PIC18F87J90 FAMILY

PIC18F87J90 Family Silicon Errata and Data Sheet Clarification

The PIC18F87J90 family devices conform functionally to the current Device Data Sheet (DS39933D) except for the anomalies described in this document.

FIGURE 2-3 FREQUENCY vs. ESR PERFORMANCE FOR SUGGESTED VCAP

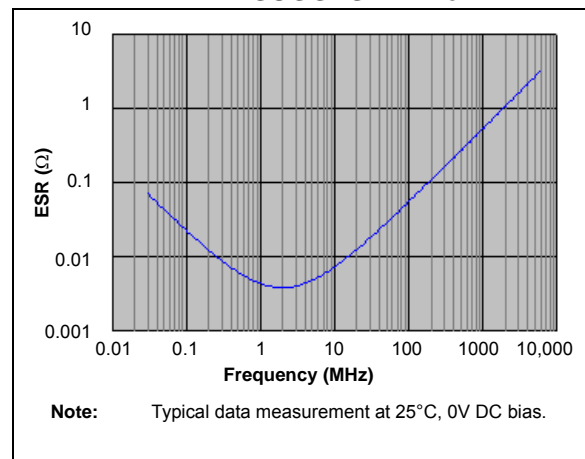
Section 2.4 “Voltage Regulator Pins (ENVREG and VCAP/VDDCORE)” has been replaced with a new and more detailed section. The entire text follows:

When the regulator is enabled, a low-ESR (< 5Ω) capacitor is required on the VCAP/VDDCORE pin to stabilize the voltage regulator output voltage. The VCAP/VDDCORE pin must not be connected to VDD and must use a capacitor of 10 μF connected to ground. The capacitor type can be ceramic or tantalum. Suitable examples of capacitors are shown in [Table 2-1](#). Capacitors with equivalent specifications can be used.

Designers may use [Figure 2-3](#) to evaluate ESR equivalence of candidate devices.

FIGURE 2-4 DC BIAS VOLTAGE vs. CAPACITANCE CHARACTERISTICS

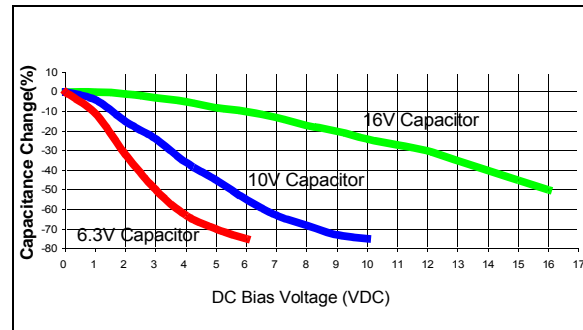
In addition to temperature tolerance, the effective capacitance of large value ceramic capacitors can vary substantially, based on the amount of DC voltage applied to the capacitor. This effect can be very significant, but is often overlooked or is not always documented.

Typical DC bias voltage vs. capacitance graph for X7R type and Y5V type capacitors is shown in [Figure 2-4](#).

When selecting a ceramic capacitor to be used with the internal voltage regulator, it is suggested to select a high-voltage rating, so that the operating voltage is a small percentage of the maximum rated capacitor voltage. For example, choose a ceramic capacitor rated at 16V for the 2.5V core voltage. Suggested capacitors are shown in [Table 2-1](#).
